Changes to v13 (2015-07-20)

Driver Board

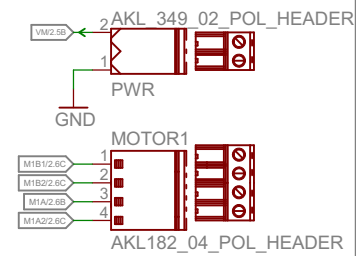
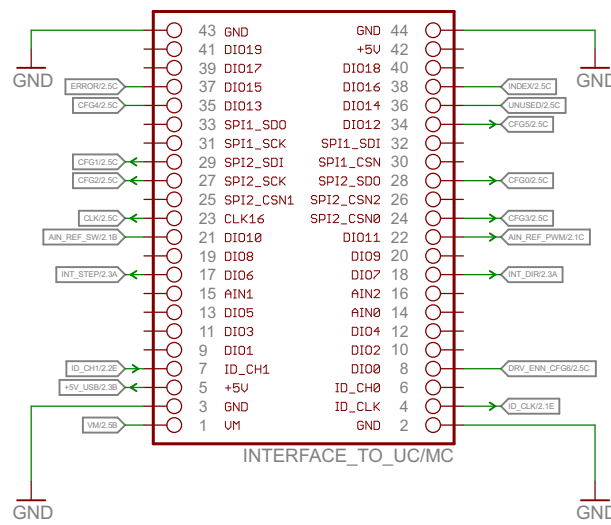
- Adapted footprint to avoid of production issues(noncritical)
- minor changes of design resulting from adaption of footprint

Please keep positions of all interconnectors if not absolutely impossible.
